KOREAN MISSION CHURCH

PRELIMINARY PLAN NO. 120240050 AND

FINAL FOREST CONSERVATION PLAN NO. F20240360

An application to create one lot for one existing single-family detached dwelling unit and one lot for a religious institution, including adult daycare.

Figure 4 – Preliminary Plan

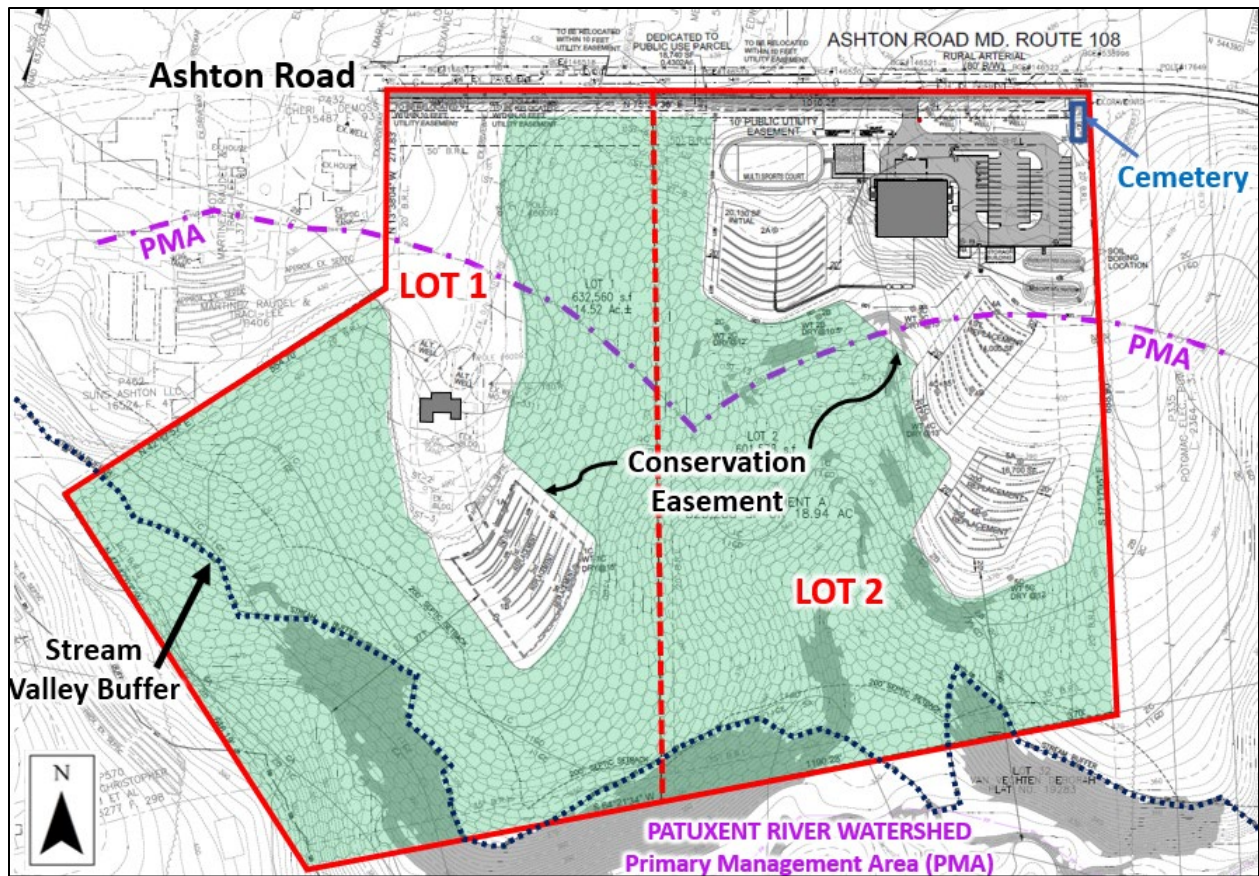
The existing single-family detached house and accessory buildings on the west side of the Property will remain on proposed Lot 1 (14.52 acres) and a new religious assembly/church building with a 100-seat sanctuary and adult day care center, along with a multi-use sports court, and pavilion will be constructed on Lot 2 (13.81 acres) (Figure 4).

As illustrated on the Preliminary Plan (Figure 4) and Tables 1 and 2, the lots are adequately sized to meet the RC development standards and accommodate the proposed uses, on-site

- a) Show resolutions and approval letters on the certified set.
- b) Include the approved Fire Department Access Plan.
- c) Update the gross tract area to 28.76 acres to reflect the surveyed area.
- d) Update the landscape and lighting plan to include canopy trees in the parking lot islands and every 30 feet on center between the parking lot and the eastern property line, starting at least 50 feet south of the cemetery boundary.

Figure 5 – Proposed Frontage Improvements

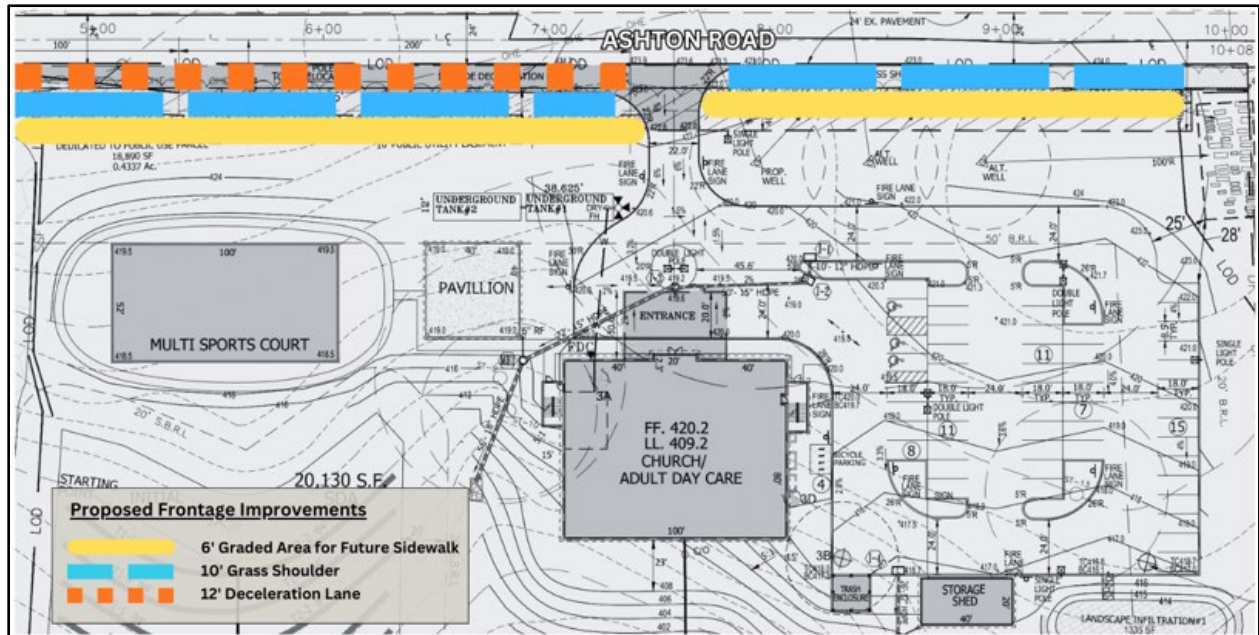
frontage, as recommended by the Master Plan. As part of this Application, the Applicant is required to provide a 12-foot-wide deceleration lane along the east portion of the Property's frontage on Ashton Road to comply with the MDOT-SHA requirements. Additionally, the Applicant is responsible for providing a ten-foot-wide (10 ft) grass shoulder and a graded area of six (6) feet for the future installation of a concrete sidewalk to be built by others (Figure 5). Internal vehicular circulation is proposed to be two-way.

- a) All land necessary to accommodate forty (40) feet from the existing pavement centerline along the Subject Property frontage for Ashton Road.
15. Before the recordation of the plat, the Applicant must satisfy all necessary requirements of MDOT SHA to ensure construction of a twelve-foot-wide (12 ft) deceleration lane along the east portion of the Property frontage on Ashton Road, as shown on the Certified Preliminary Plan.

16. Before the recordation of the plat, the Applicant must satisfy all necessary requirements of MDOT SHA to ensure the construction of a ten-foot-wide (10 ft) grass shoulder along the Property frontage on Ashton Road, as shown on the Certified Preliminary Plan.

17. Before the issuance of a building permit, the Applicant must grade the Property frontage on Ashton Road for the future installation of a six-foot-wide (6 ft) concrete sidewalk, to be built by others in the future, as shown on the Certified Preliminary Plan.

Figure 7 – Ground penetrating radar reflections with probable and possible grave locations noted

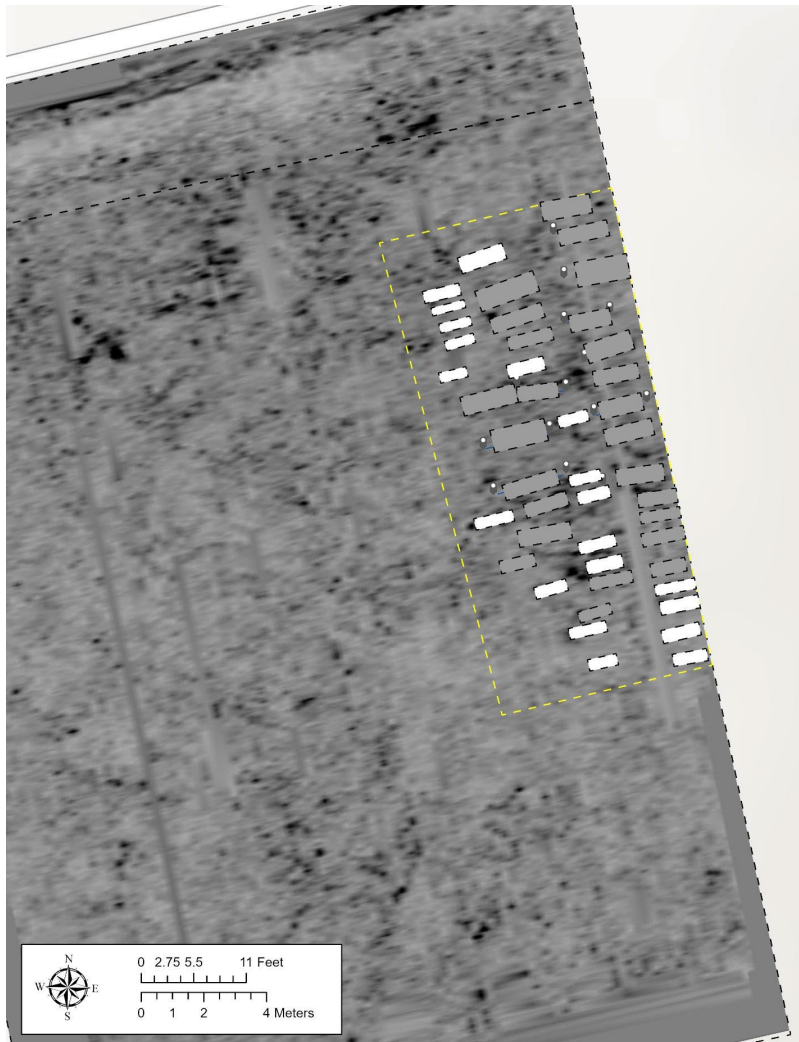
Staff received a copy of the draft GPR report in April 2025 and reviewed it. While concurring with most of the findings, staff raised concerns that some of the GPR results were ambiguous. Roots, rocks, and moisture-retained areas in different soils also produce radar reflections that can make GPR results difficult to interpret. In such cases, archaeologists sometimes strip away the relatively thin layer of dark-colored topsoil to reveal the lighter colored subsoil beneath. The shafts where historical graves were dug and then back filled, in contrast in color and texture with the surrounding undisturbed subsoil, allowing unmarked graves to be identified. Staff recommended corrections to the historical background and additional ground testing to verify that GPR reflections found in the vicinity of the proposed parking were not unmarked graves.

The Applicant's archaeological consultant conducted the recommended additional testing in May 2025 in an area within the portion of proposed parking nearest to the cemetery and between the proposed parking and the cemetery. Methods consisted of shallow excavations intended to remove the dark topsoil and expose the underlying lighter subsoil, exposing any shafts associated with unmarked graves (Figure 7). No additional graves were found in the vicinity of the proposed parking. Staff reviewed the revised report and concurred with the findings in June 2025.

Figure 8 – 25 foot separation between the parking lot and the cemetery boundary

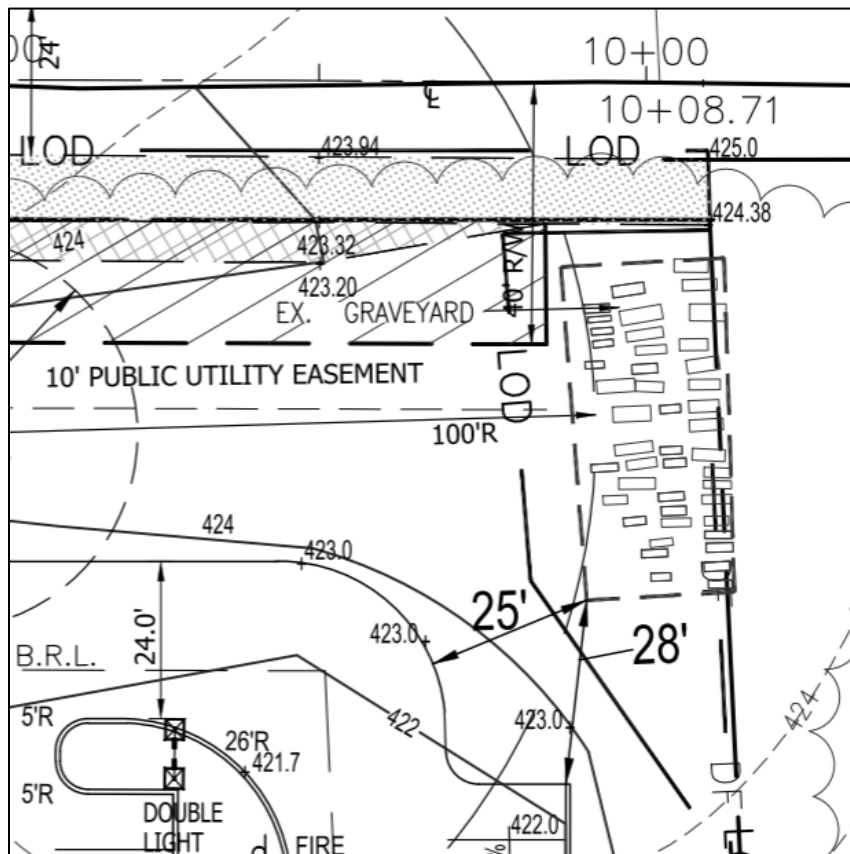
Historic Preservation staff reviewed the Applicant's Preliminary Plan, including proposed lot lines, buffer between proposed hardscape parking and the cemetery, and the landscape plan in the vicinity of the graveyard. Staff determined that the proposed lot lines are consistent with the long-term preservation of the cemetery, that the proposed 25-foot buffer between the parking and cemetery is adequate, and the proposed landscape plan will not harm the cemetery.

Figure 9 – Simplified Landscape Plan

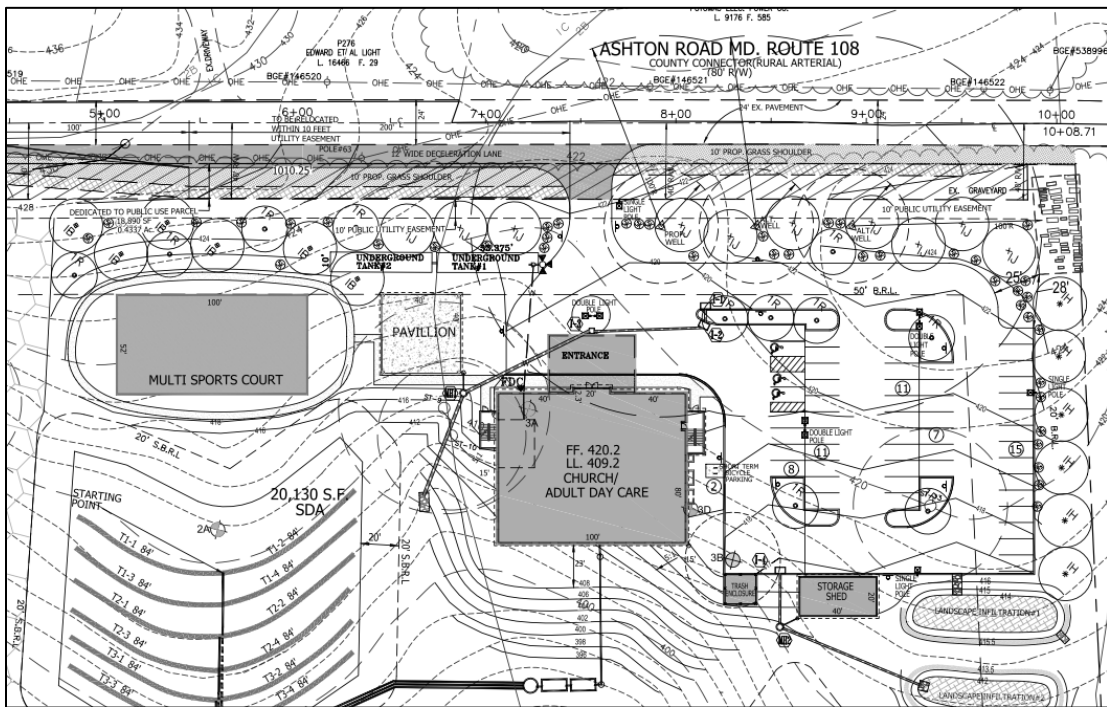
Subsection 50.4.3.N of the Subdivision Regulations requires a landscape and lighting plan to be submitted with Preliminary Plans for places of worship and institutional uses. The landscape and lighting plan submitted by the Applicant shows that the parking lot landscaping and outdoor lighting standards in Section 59-6.2.9 can be met.

As conditioned, the Applicant will be adding canopy trees every 30 feet on center and additional shrubs along the eastern edge of the parking lot to supplement the proposed understory trees shown in Figure 9. As conditioned, the understory trees in the parking lot

planting islands will also be replaced with canopy trees to meet the minimum 25% parking lot shading requirement. No canopy trees will be planted within 50 feet of the cemetery boundary.

Figure 10 - Variance Trees

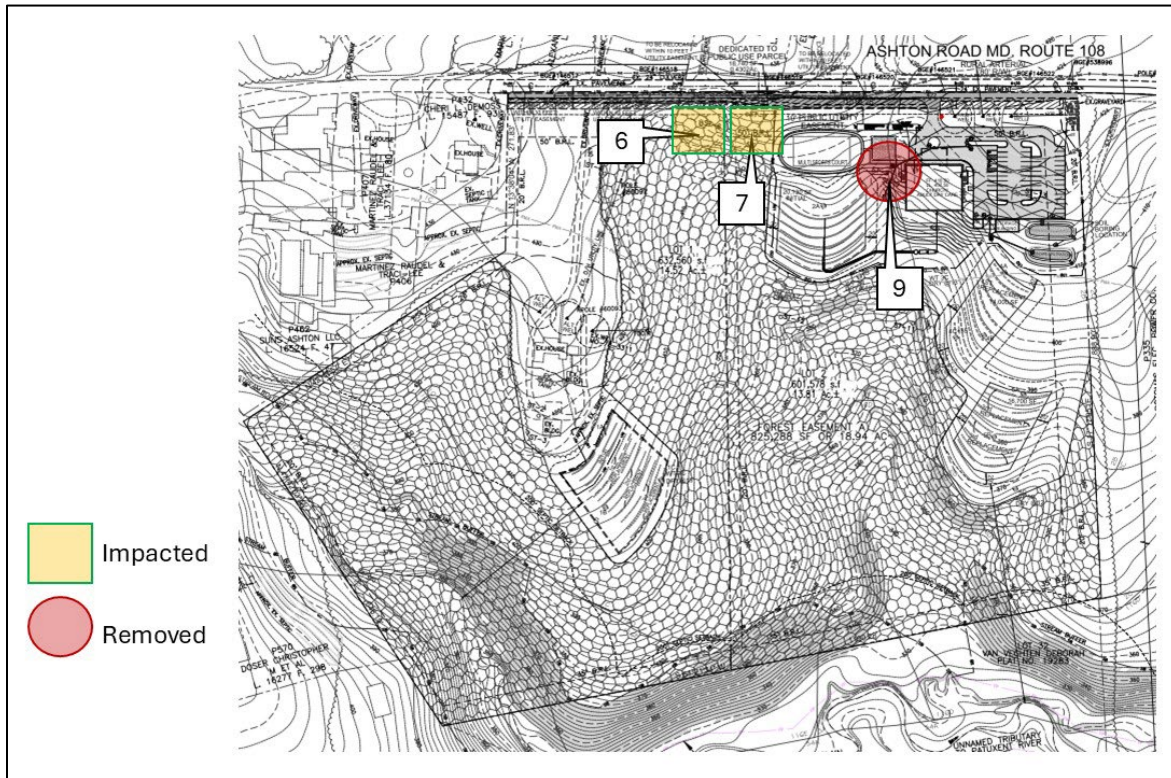
The Applicant has demonstrated that the denial of the Variance request would cause an unwarranted hardship by preventing the reasonable and significant development of this property for the existing single family house and a new church building, with accessory structures. Section 22A-21 of the County Forest Conservation Law sets forth the findings that must be made by the Planning Board or Planning Director, as appropriate, in order for a variance to be granted.

The Applicant has not proposed any mitigation on the plans or in the Variance Request.

A condition of approval has been added that the Applicant include mitigation at a rate that approximates the form and function of the trees removed. These trees will be replaced at a ratio of approximately 1 inch caliper for every four inches removed, using trees that are a minimum of three caliper inches in size. This results in a total mitigation of 9.25 inches of trees, using a minimum 3-inch caliper, overstory trees native to the Piedmont Region of Maryland on the Property, outside of any rights-of-way and utility easements.
